Customer Notification

V850ES/Dx2

32-bit Single-Chip Microcontrollers

Operating Precautions

Figure: Additional Measures in case AFCAN clock is active when waking up

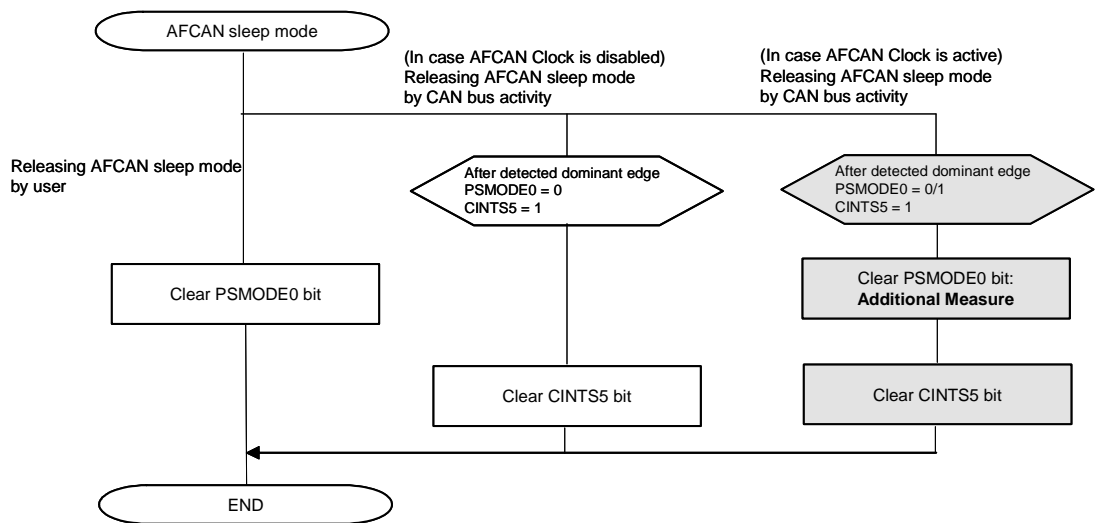
The following flowchart illustrates, how and whether additional measures have to be taken in software, to avoid the *wakeup dead time*.

No. 1	AFCAN: Sleep Mode Wakeup (Specification change notice)
<p><u>3.3 Affected Applications</u></p> <p><u>3.3.1 Applications not waiting until SLEEP mode is left</u></p> <p>If bus transceivers are used in conjunction with AFCAN, which will propagate the CAN bus signal to AFCAN permanently (not switched off or not in power saving modes), or, if bus transceivers are used in conjunction with AFCAN, which will propagate the unmodified CAN-Bus signal when waking up from a power save mode, the wakeup dead time lasts from the first recessive-to-dominant edge of the CAN-Bus signal, which generates the wake-up, until the next recessive-to-dominant edge of the CAN-Bus signal.</p> <p>The worst case (maximum length) of the wakeup dead time, is given by the CAN bus speed and the rule of the CAN bus about the frequency of recessive-to-dominant edges. Given by the stuffing rule, at least every 10 bits, a recessive-to-dominant edge must occur.</p> <p>If during the wakeup dead time, the CPU waits until the SLEEP mode is indicated to be cleared (either by polling the PSMODE flag, or by retrying to clear CnINTS[5]), this operating precaution is not applicable. In this case, the improvement hint according to 4.2.2 is followed implicitly. If during the wakeup dead time, the CPU does not perform any access to the AFCAN macro in any case, this operating precaution is not applicable.</p> <p><u>3.3.2 Applications using Bus Transceivers generating long-lasting dominant CAN-Bus Signals</u></p> <p>If bus transceivers are used in conjunction with AFCAN, which <i>generate a permanent or long-lasting dominant level</i> when waking up from a power save mode, the operating precaution must be considered in any case.</p> <p>In this case, the wakeup dead time lasts from the first recessive-to-dominant edge of the CAN bus signal, which generates the wake-up, until the next recessive-to-dominant edge of the CAN bus signal, depending on the behaviour of the CAN bus transceiver.</p> <p>If no further dominant edge on the CAN bus occurs (in case of some CAN transceivers, which only provide one single edge on waking up), the time until SLEEP mode is left may become endless. Therefore, the waking up procedure of AFCAN regarding software, must be adjusted according to 4.1.1.</p> <p><u>4. Software Improvement Hints</u></p> <p><u>4.1 Recommended WAKEUP Handling by Software</u></p> <p><u>4.1.1 Clearing the SLEEP Mode by Software</u></p> <p>Within the WAKEUP interrupt routine, before accessing any other register or area of AFCAN, the SLEEP mode can be canceled by software, followed by a clearance of the WAKEUP interrupt flag.</p> <p>Doing so, the AFCAN macro will start its synchronous operation right after these accesses.</p> <p>In the following C-code example, replace the objects in "<>" brackets by the hardware locations within your implementation. Use the appropriate access types, as described in the User's Manual.</p> <pre> WAKEUP INTERRUPT VECTOR --> <CnCTRL_PSMODE> = 0; /* Clear SLEEP Mode */ <CnINTS_CINTS5> = 1; /* Clear INTS5 */ ... /* following other parts of interrupt routine */ ... </pre> <p>Remark: Clearing INTS5 is required to get another WAKEUP interrupt anyway, by specification.</p>

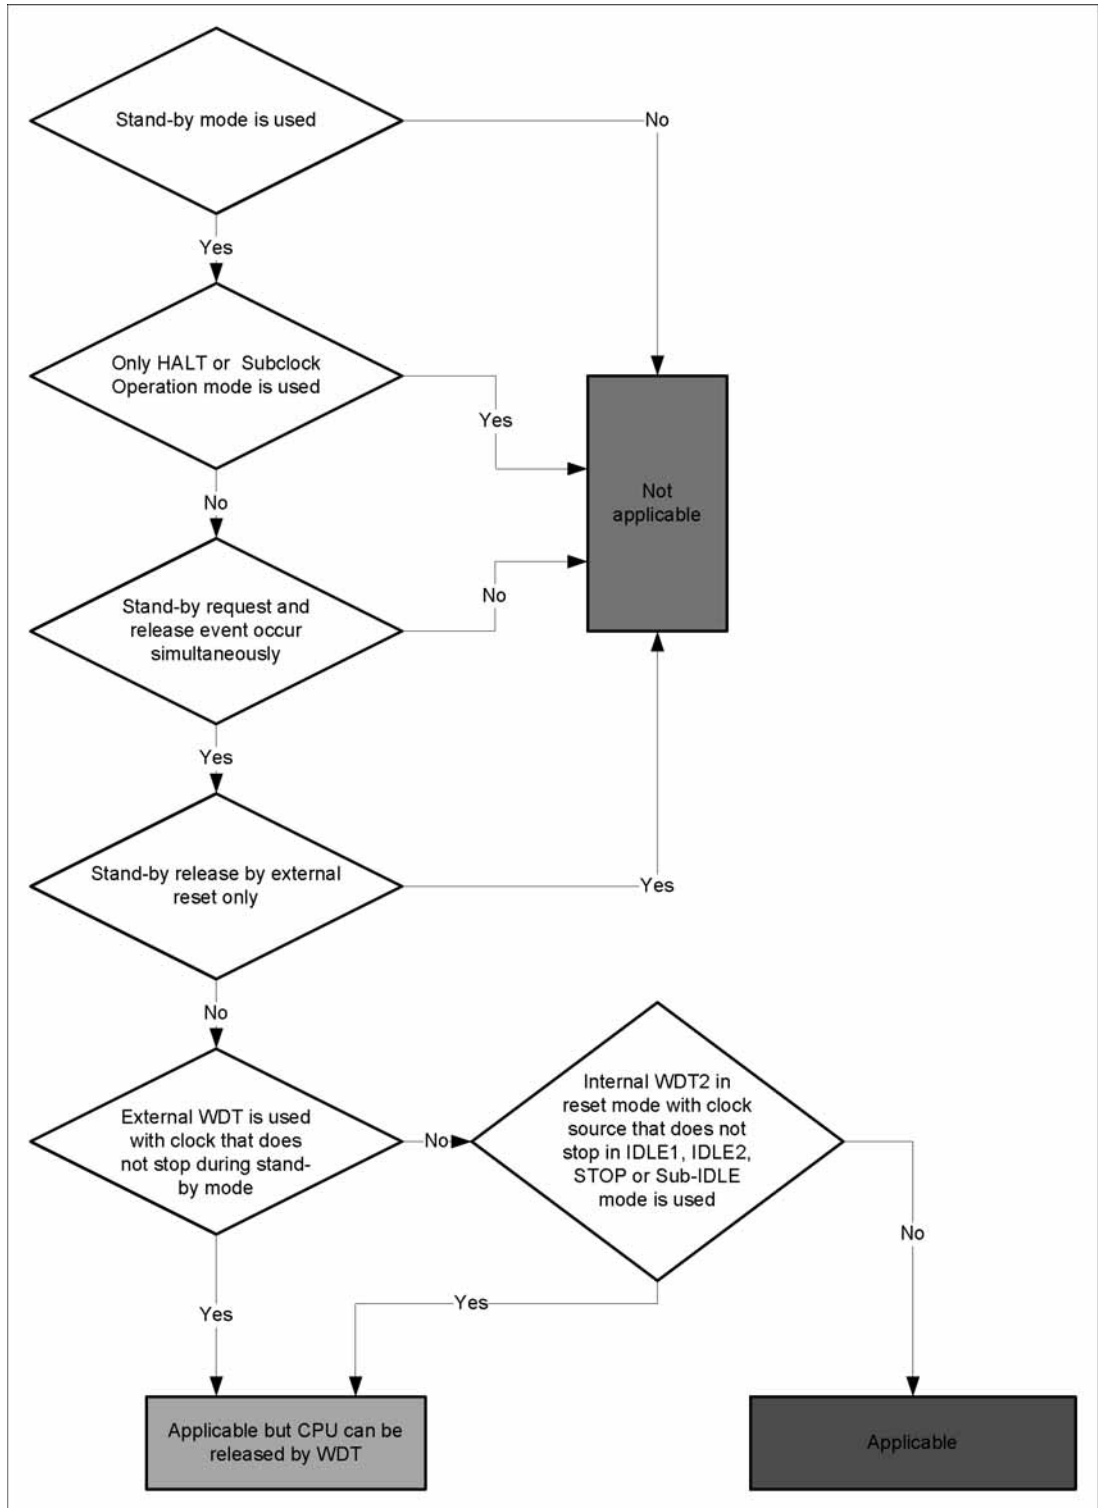
No. 2	Stand-by Mode Release (Specification change notice)
	<p><u>Description:</u> If a stand-by mode request and a wake-up event coincide with the same timing, the μC may enter the power save mode in a way that the power save mode can be released by Reset (external or internal) only. This happens only if the stand-by mode request and the wake-up event occur within a timing window of 0.46 nsec width.</p> <p>The term "stand-by mode" of the above description refers to all stand-by modes which are selected by the Power Save Control Register (PSC). The term "wake-up event" of the above description refers to any event which is configured to release the microcontroller from a stand-by mode. This can be any unmaskable or unmasked maskable interrupt (internal or external) except reset.</p> <p>Affected stand-by modes are:</p> <ul style="list-style-type: none"> - Idle1 Mode, - Idle2 Mode, - Sub-Idle Mode and - Stop Mode <p>Not affected stand-by mode:</p> <ul style="list-style-type: none"> - Halt Mode <p>Please see the flowchart on the following page.</p>

Please see the following flowchart to check if the described behaviour might be relevant for a particular application:
